**NOTICE OF A REGULAR MEETING
OF THE DESIGN REVIEW BOARD OF THE TOWN OF CLARKDALE**

STAFF REPORT

Agenda Item: Discussion / possible action regarding a Columbarium application for DRB-090715 Spirit of Joy Church.

Agenda Item: Discussion / possible action regarding a sign application for Pine Shadows DRB-090712 for a sign alteration to the existing Pine Shadows Community sign.

1. Elevation
2. Future Elevation
3. Site Plan
4. Construction details

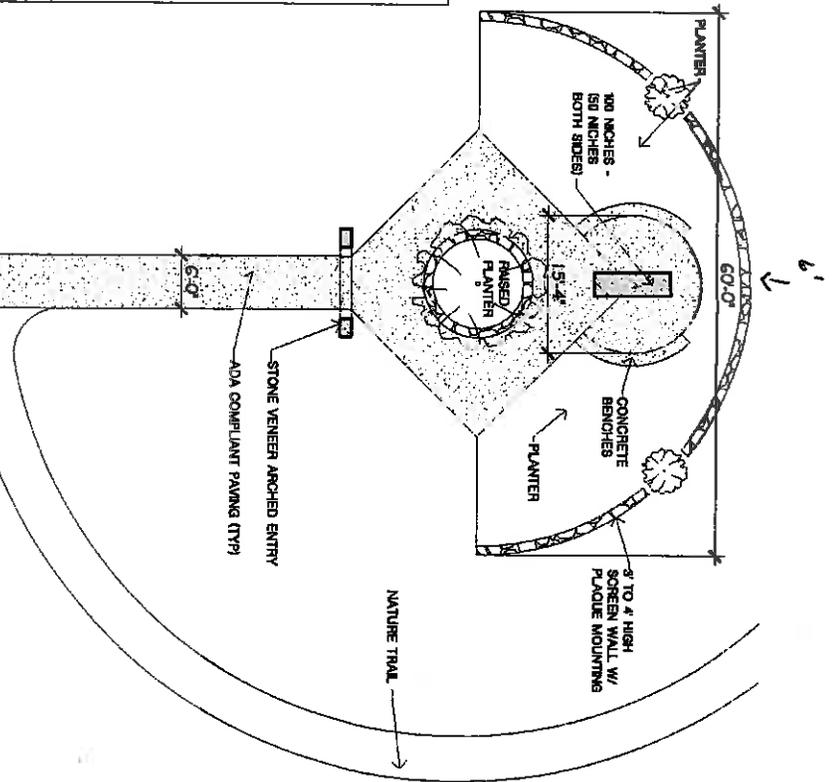
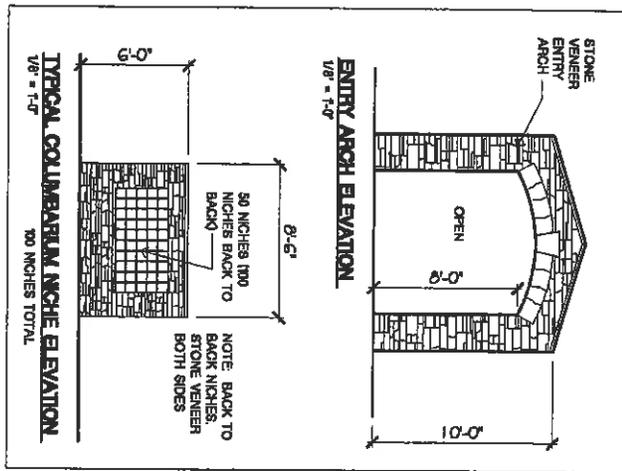
The proposed Columbarium structure will be 6' high x 8' - 6" wide with 50 niches on either side of the structure for a total of 100 niches. Two additional structures of same size and design may be built on the west and east of first Columbarium if needed in the future. A stone veneer finish is proposed. Two concrete benches will be placed on either side of the Columbarium.

The Columbarium area will be bordered on the north by three 3' to 4' high screen wall sections broken up by two planting areas. The walls will be free-form stucco with a capstone top finish. Memorial plaques will be mounted on the walls. The ground surface in front of proposed wall will be of crushed granite material. In the center of the Columbarium will be a raised planter.

A 6 foot-wide ADA-compliant paved walkway will connect the church patio fellowship area with the proposed Columbarium. At the end of the walkway will be a 10' high archway with an 8' high entrance. The archway will have stone veneer that will match the church. A connection from the walkway to the existing trail that intersects with the Crossroads at Mingus trail system is proposed.

1. The Spirit of Joy Church proposed Columbarium installation and archway must match the stone veneer of the approved Spirit of Joy Church plot plan.
2. All landscaping must conform to Chapter Nine of the Town of Clarkdale Zoning Code.

**1/2" x 2' x 3' DF Cantilevered sign
MDO signboard as substrate**

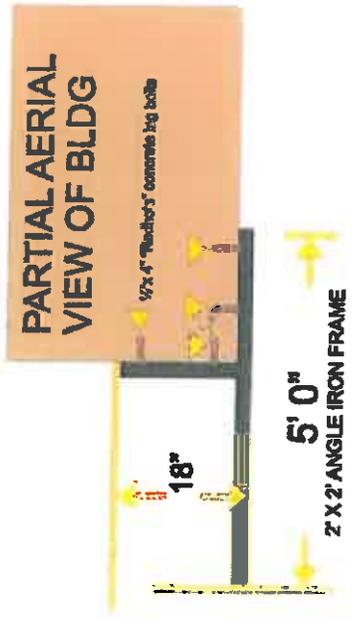
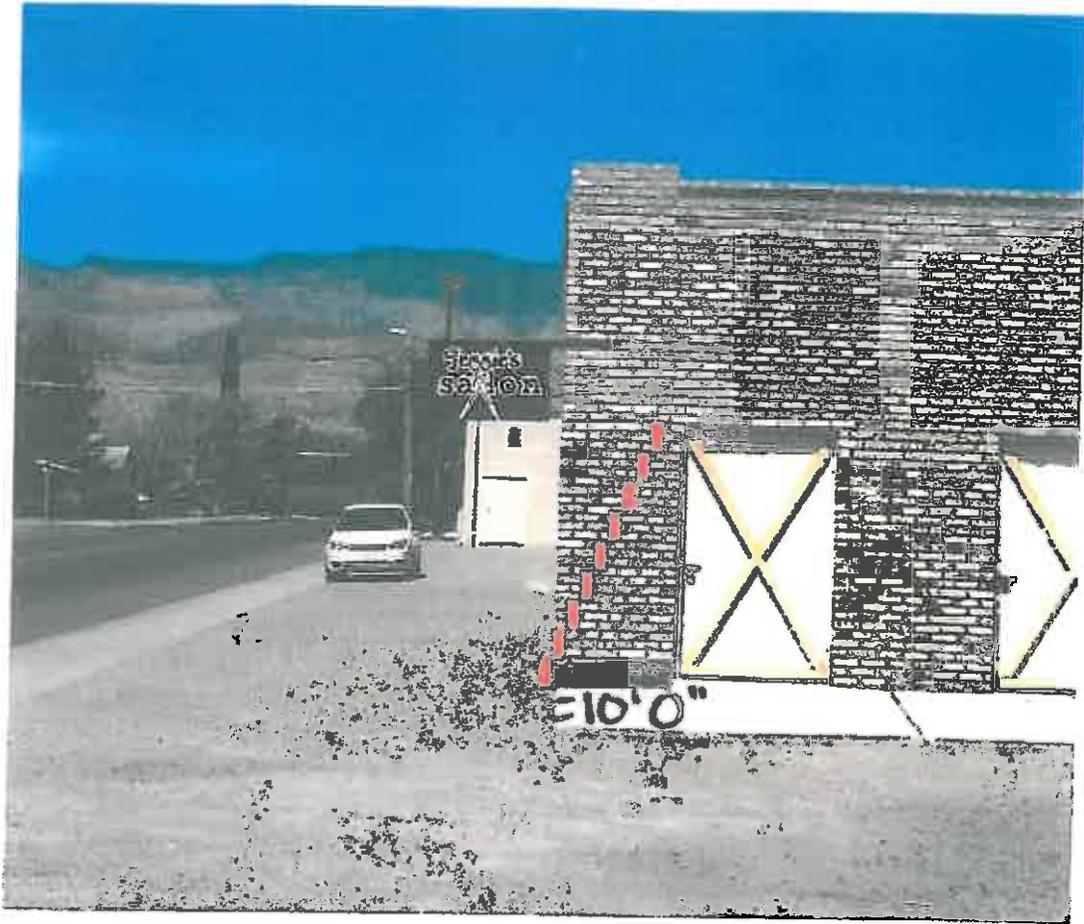
The proposed Projecting sign will be 2' x 3', 6 sq. ft., double sided wooden sign, UV grade photo vinyl application. The lettering styles will be Bookman Bold and Serifa.

The proposed projecting sign will be hung below the 13.5 ft. high wall facing First South Street. The projecting sign will be mounted on a 5' x 2" x 2" angle iron frame and attached to the wall with 12" x 4" "Redhots" concrete lag bolts. (Refer to photos attached).

A wall sign is proposed on the left of the front door entrance to the Salon. The wall sign will be 16" x 24" (32 square feet) and made of wood with UV grade photo vinyl application; to be mounted with (4) "Redhots" masonry lag bolts in each corner. Proposed signage will have no lighting. (Refer to photos attached).
